Central Coast
LOCAL PLANNING PANEL MEETING
Business Paper
22 April 2021

4.1 Section 8.2 Review of Determination - DA/162/2020 - Mixed use
development - 135-136 Tuggerah Pde, Long Jetty..... 16

Reference: DA/162/2020 - D14456429
Author: Erin Murphy, Senior Development Planner
Manager: Emily Goodworth, Section Manager, Development Assessment
Approver: Andrew Roach, Unit Manager, Development Assessment

Figure 7 – GFA Diagram extract

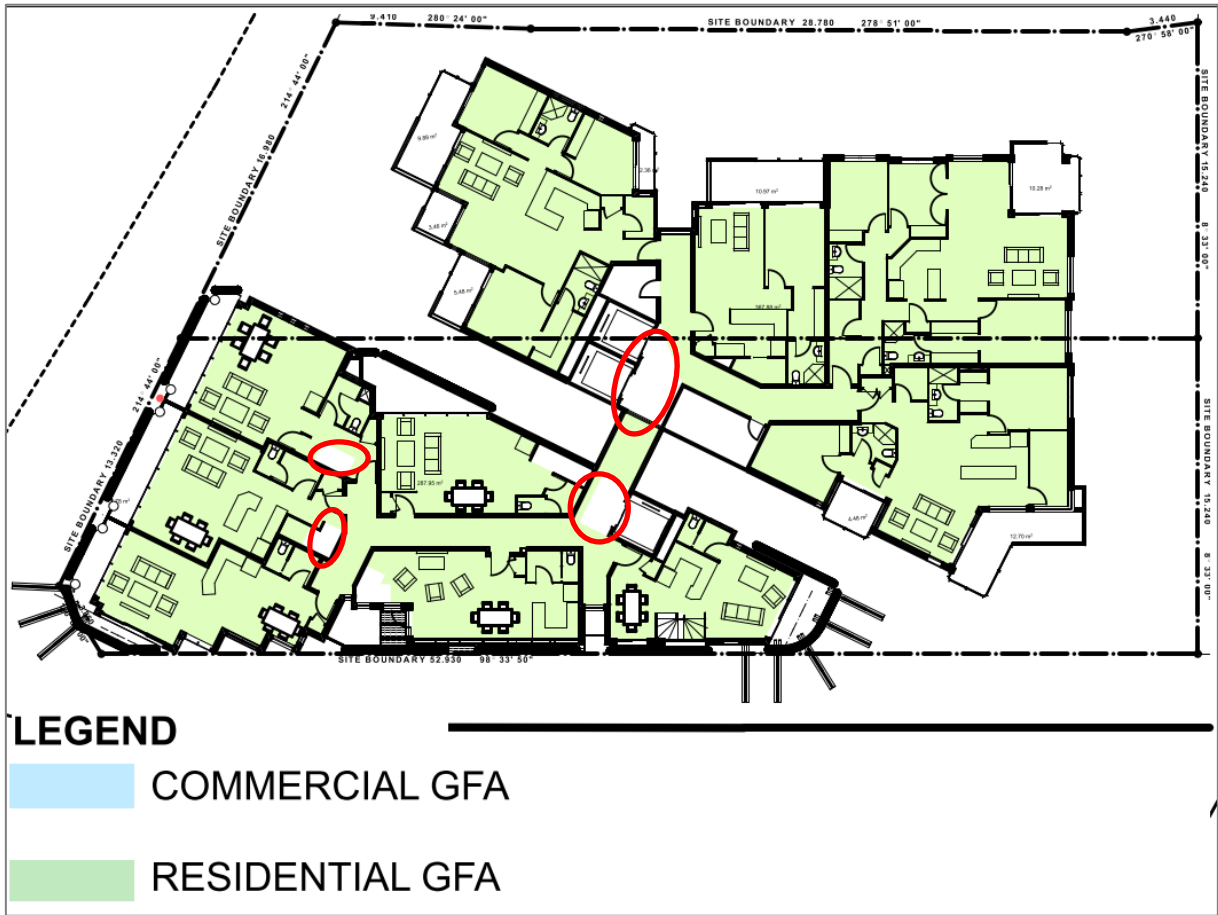
Areas of circulation in front of the lifts and in hallways have been excluded in some areas when they form part of the floor area. While common *vertical* circulation, such as lifts and stairs, can be excluded, horizontal circulation, such as hallways, cannot be excluded. In addition, the area of stairs between single units have been excluded at both levels, not just the voids. Stairs within a single unit are not 'common' vertical circulation and are not excluded from GFA. These areas are shown circled in red in Figure 7.

As such, the applicant's FSR calculations are inaccurate and the clause 4.6 written request is based on a lesser figure than should be calculated.

Figure 8 – Basement Level – additional deep soil area

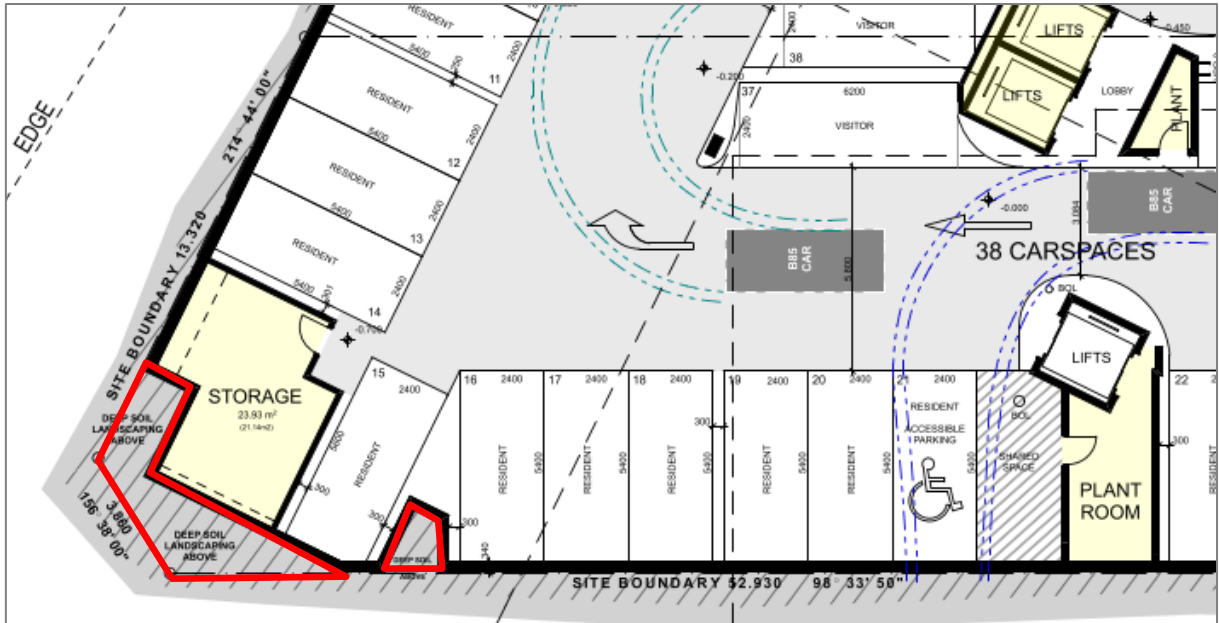
The proposal, as amended, provides some minor amendments to the basement to allow for some additional deep soil planting, as shown outlined in red at Figure 8. These amendments do not provide significant opportunities for deep soil planting at the Pacific Street frontage that would assist in providing an appropriate character and transition in scale at a zone interface with the adjacent R2 Low Density Residential zoned land. It is noted that no amended landscape plan has been provided.

The documentation does not satisfactorily address the objectives and design criteria of the Apartment Design Guide.

Above: Original proposal -elevation to the Tuggerah Lakes

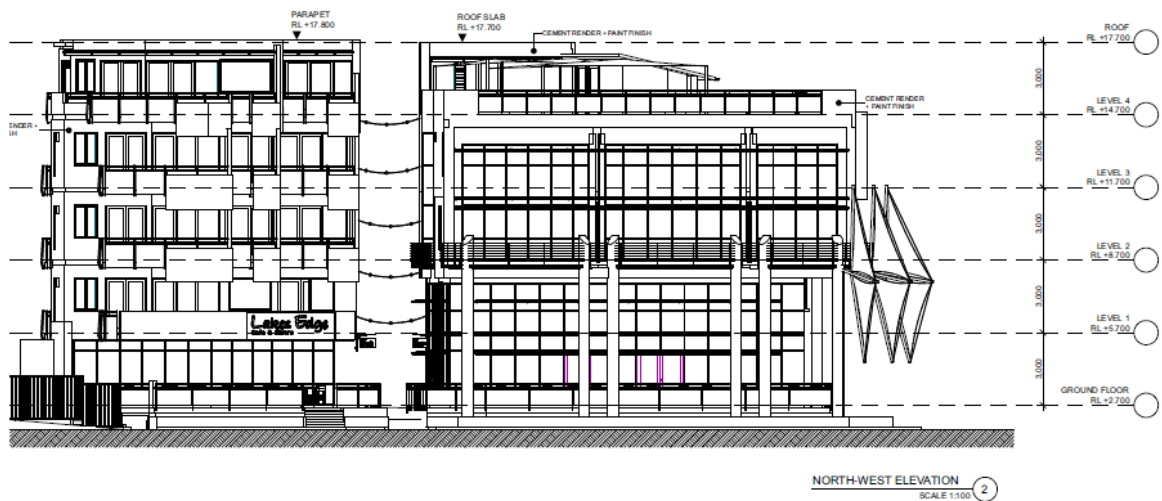
architectural character, all contribute to the bulk, scale and size of the development which is considered incompatible with the current and desired coastal and built environment.

Figure 10 – Areas on non-compliance with half of ADG building separation level 4 (fifth storey) (9m)

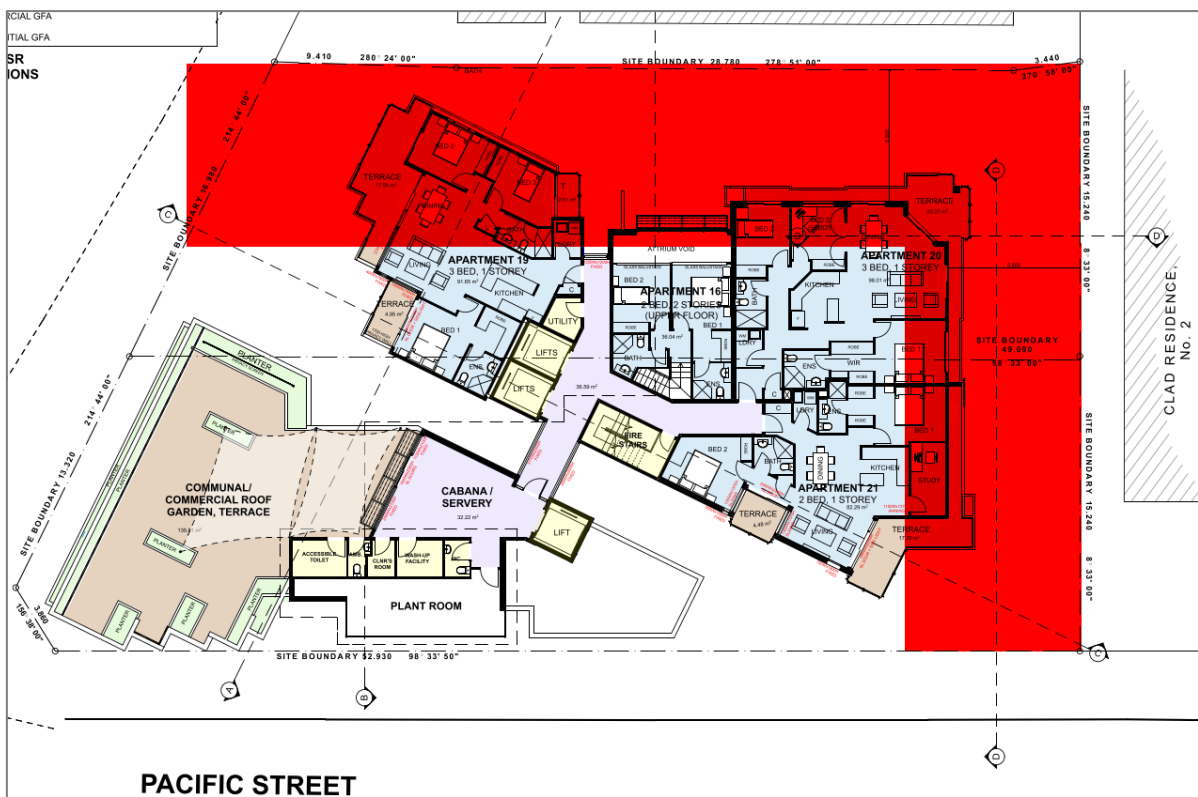
As shown in Figures 9 and 10, relatively minor variations occur at the lower levels with balconies within 5.3m of the northern boundary and 5.6m to the eastern boundary (12% variation). These setbacks represent significant variations level 4, where 9m is required, with the same setback as the lower levels and resulting in an up to 3.7m or 41% variation.

Above: Areas on non-compliance with half of ADG building separation levels 5 and above (9m)

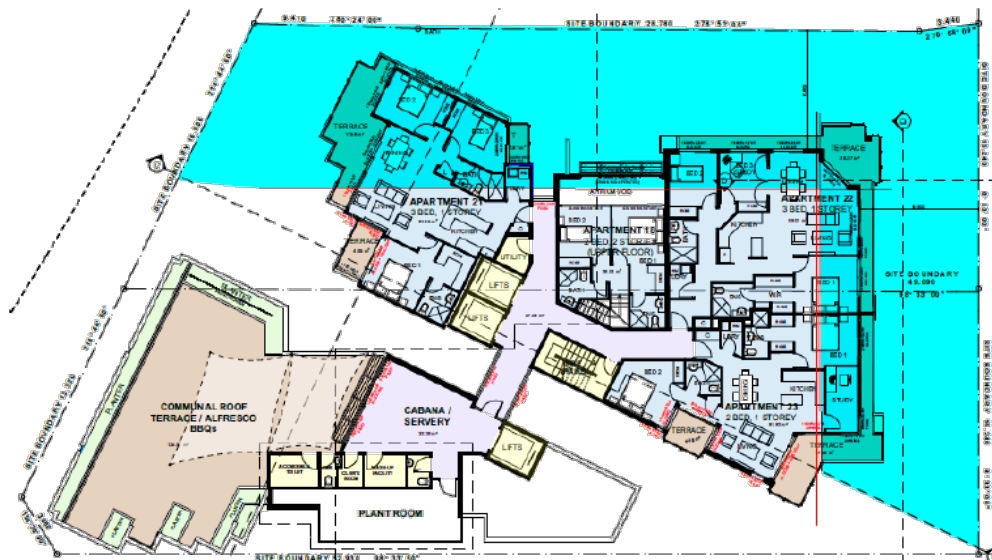
The proposal fails to meet half of the required building separation (indicated in blue) below:
